BEACON PLANNING BOARD
One Municipal Plaza - Courtroom
BEACON, NEW YORK 12508
Phone (845) 838-5002 Fax (845) 838-5026

The Planning Board will meet on **Tuesday, May 10, 2016** in the Municipal Center Courtroom. A training workshop will take place at 7:00 p.m. and the regular meeting will begin at 7:30 p.m.

On behalf of the Applicant for the above referenced project, Hudson Land Design (HLD) has revised the subdivision set in response to Lanc & Tully's April 7, 2016 comment letter, and F.P. Clark's April 8, 2016 comment memorandum. Below is a point-by-point response to the comments received.

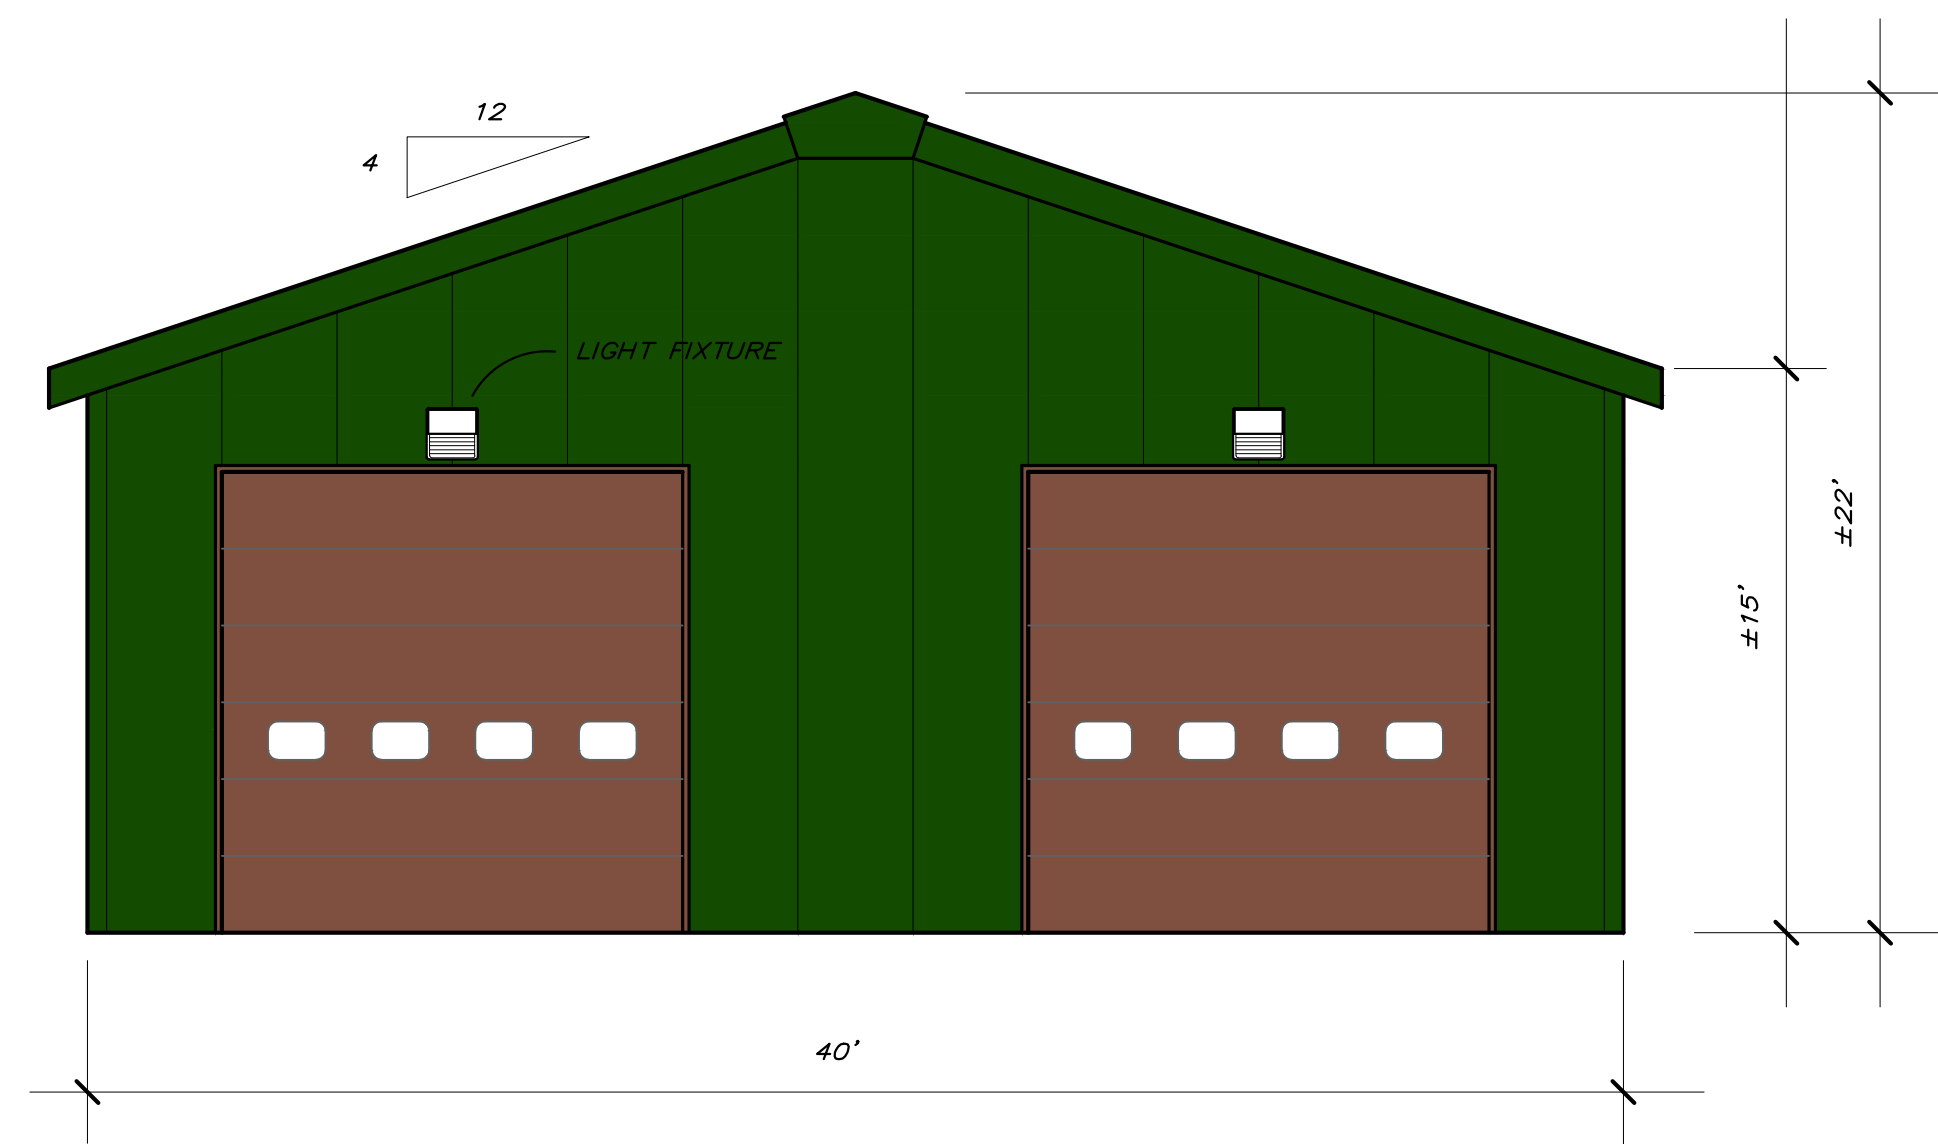
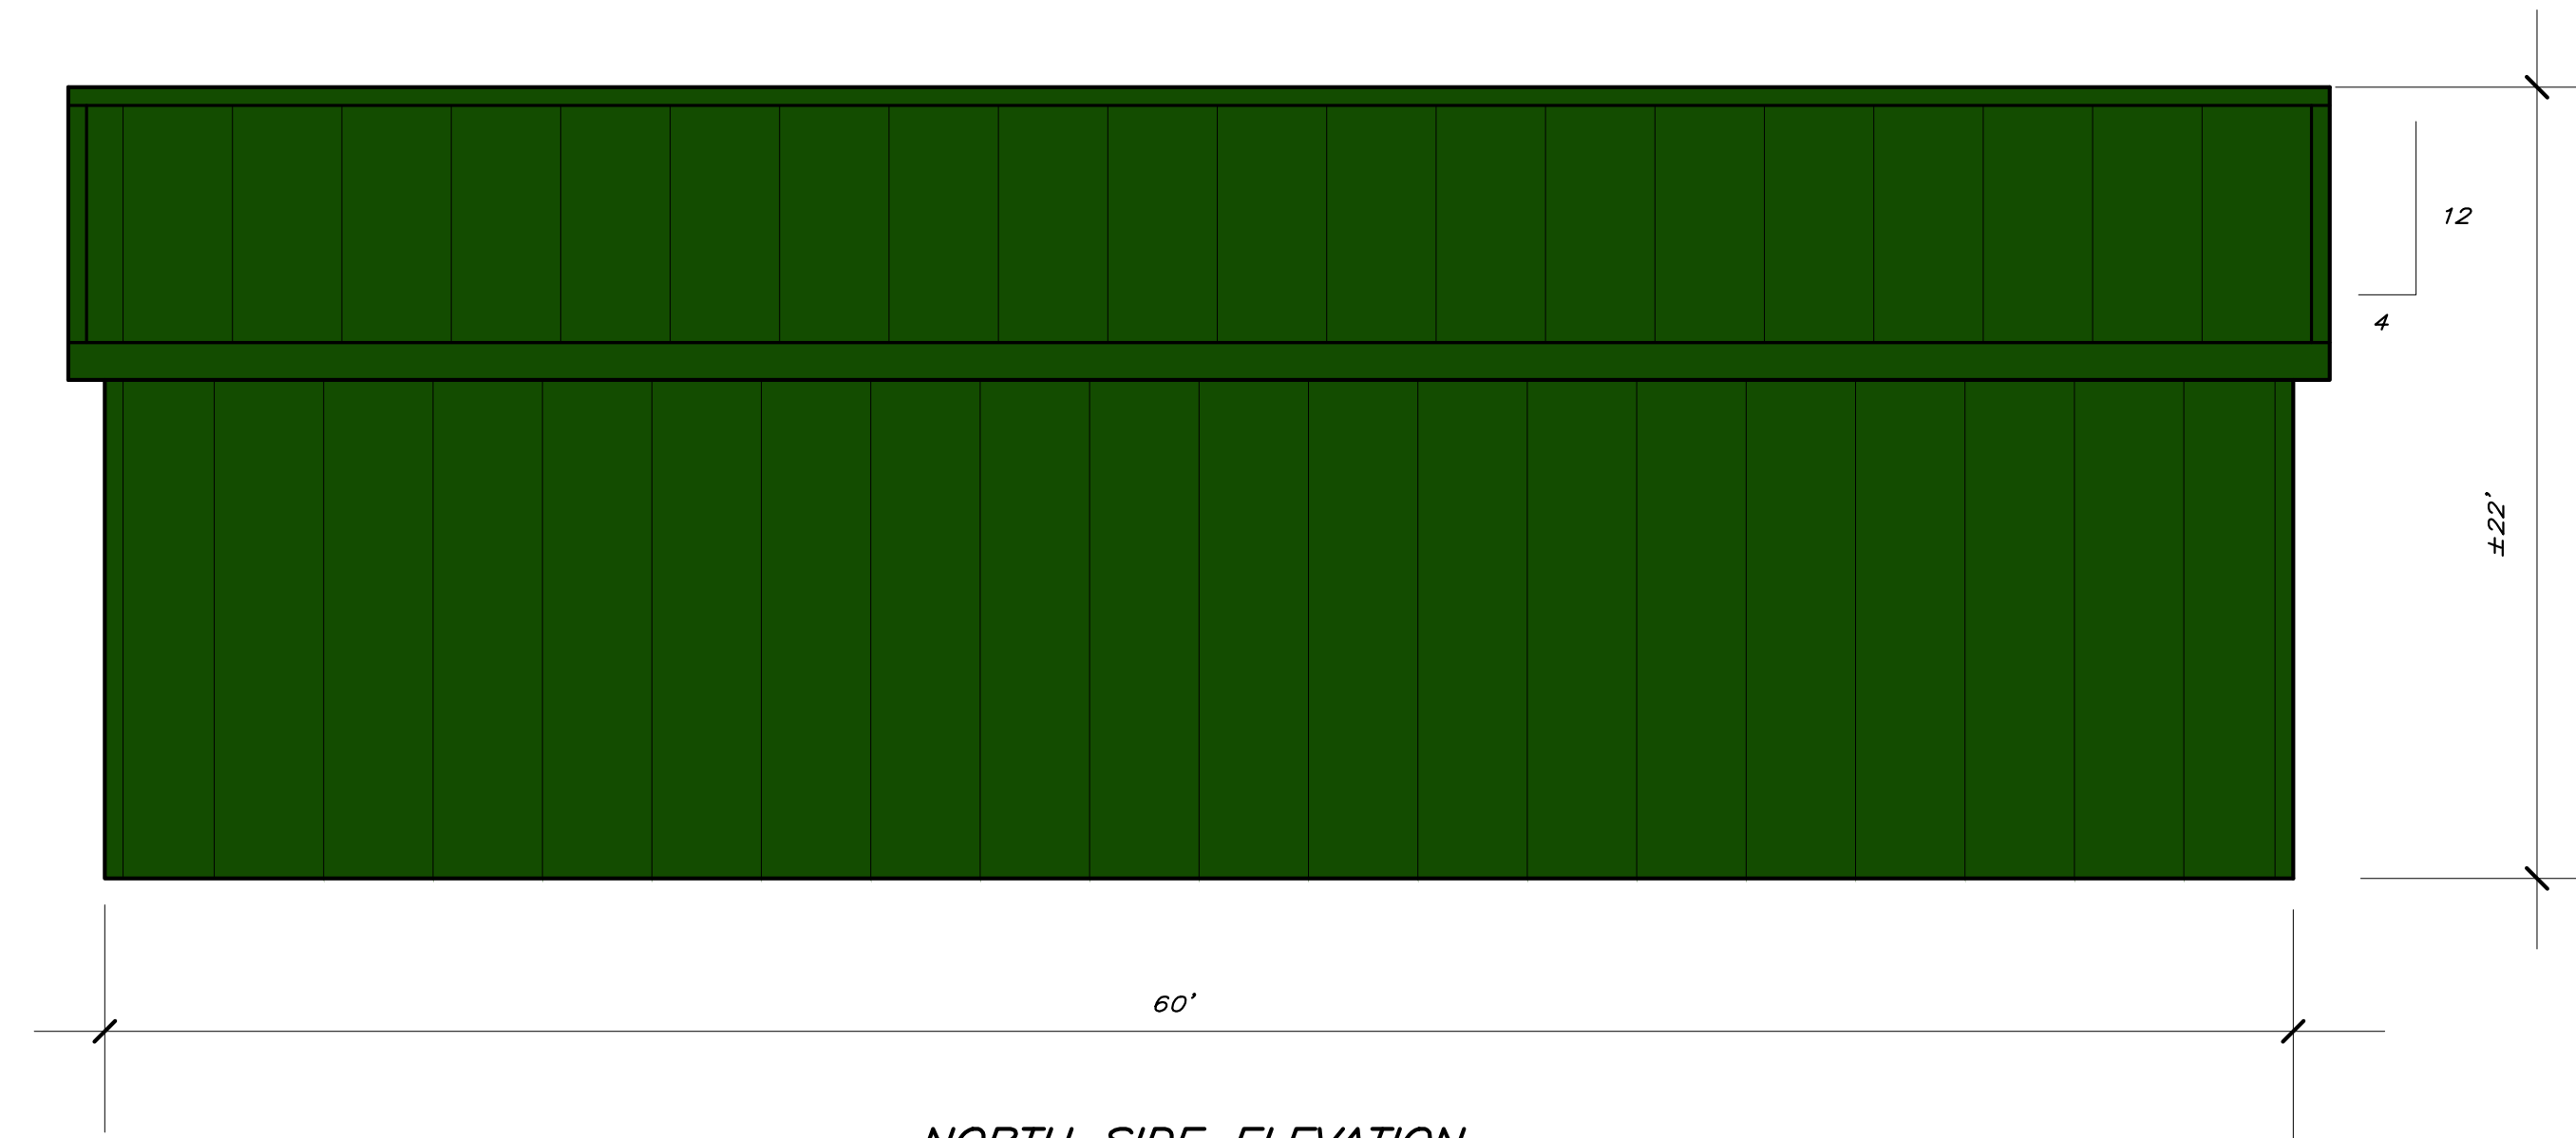
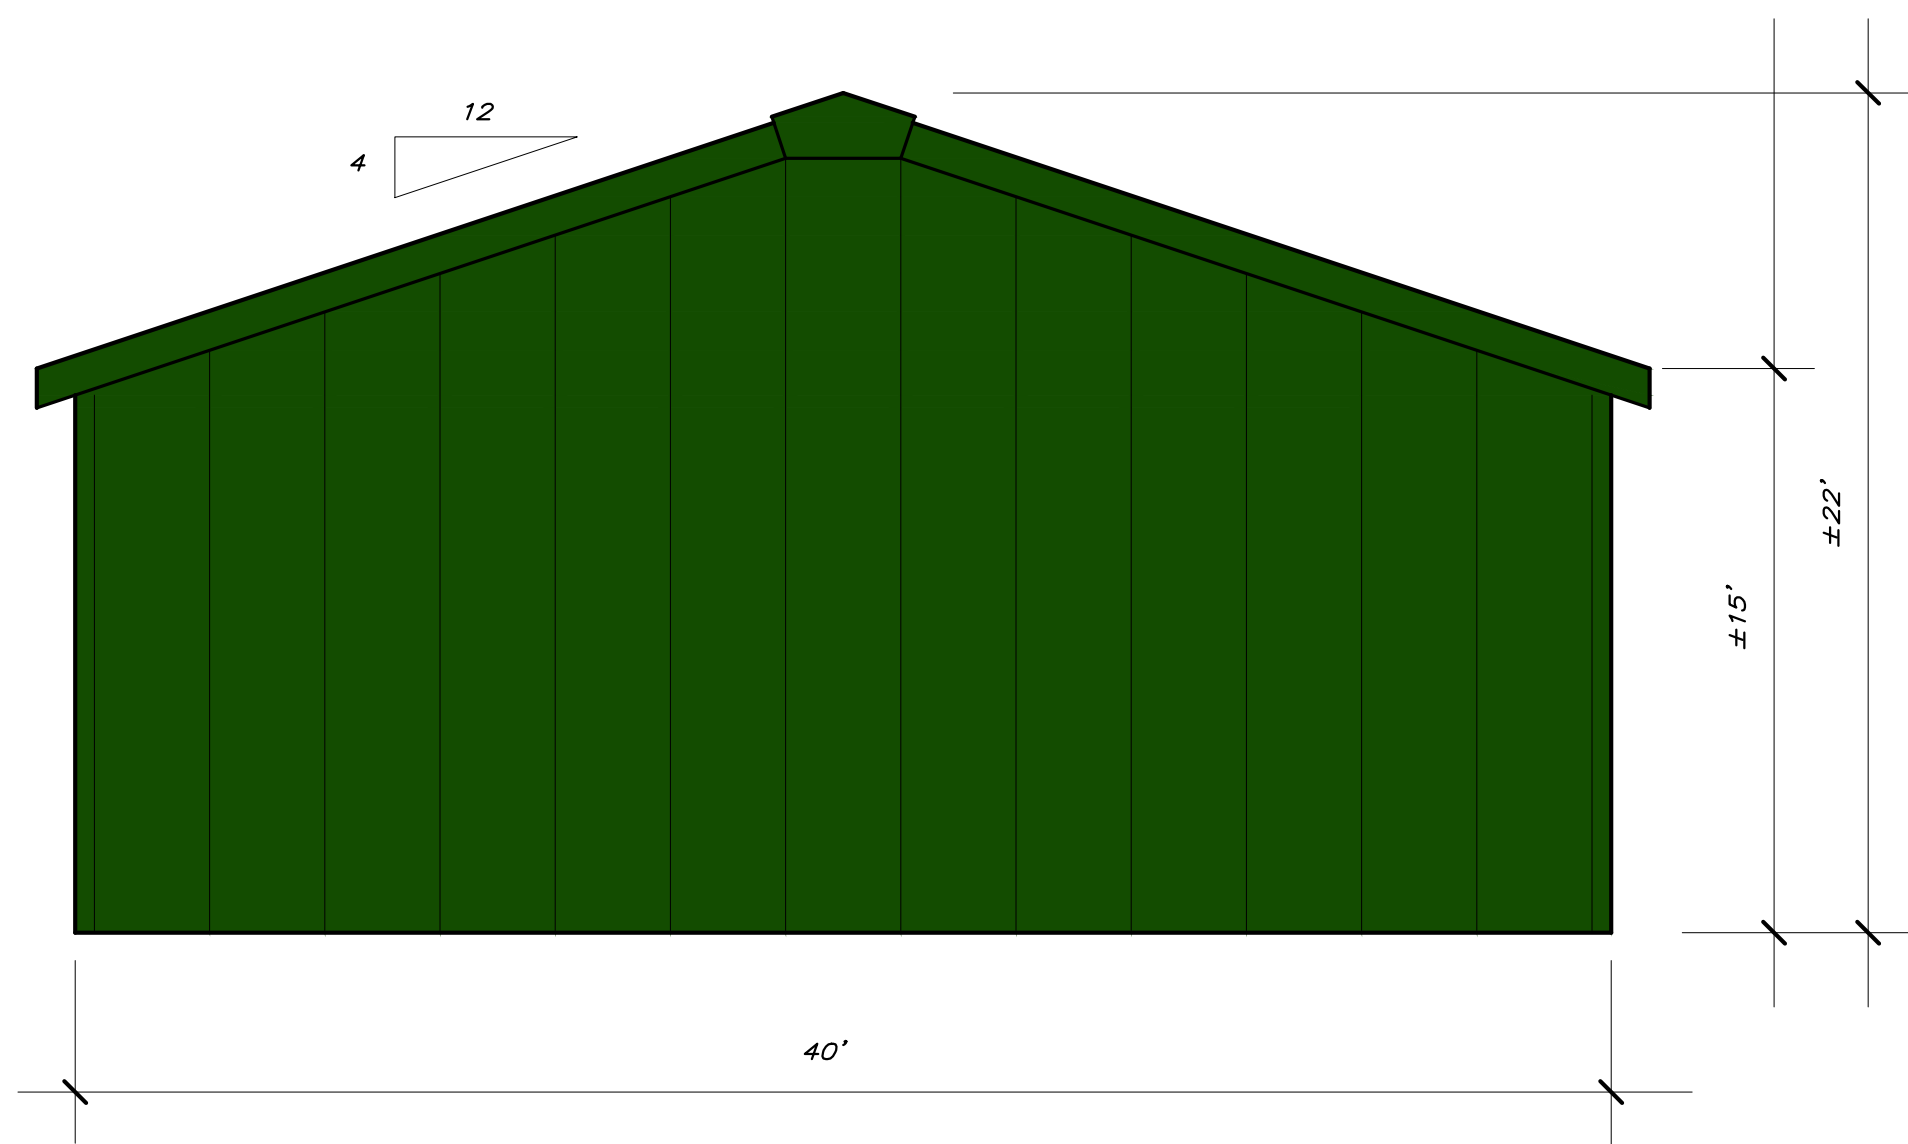
Our office has reviewed the plan entitled "DIA Art Center – Building Elevations", dated April 19th, 2016, as prepared by T.M. Depuy Engineering & Land Surveying, P.C. The applicant has submitted the building elevations plan, along with a color chart for the Planning Board to discuss the colors for the proposed maintenance building to be constructed at the site.

As previously noted in our April 7, 2016, all engineering comments have been addressed. If you have any questions, or require any additional information, please do not hesitate to contact our office.

WATER SERVICE CONNECTION DETAIL
NOT TO SCALE

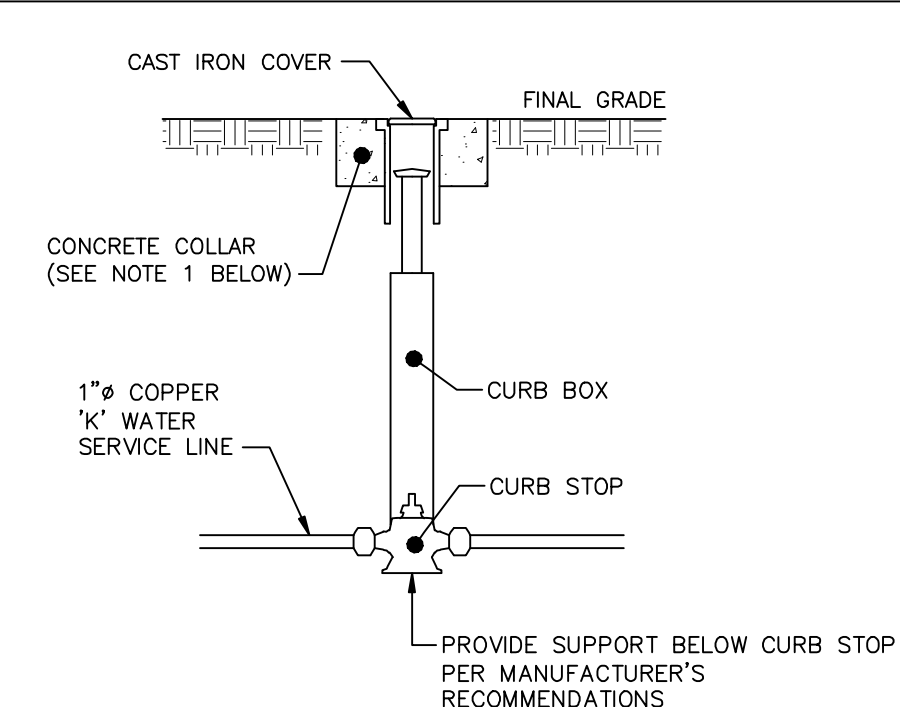
8. The note has been revised to reflect 4" diameter pipes.
9. The tapping detail has been revised to show a tapping saddle model BR1B by Mueller or approved equal.
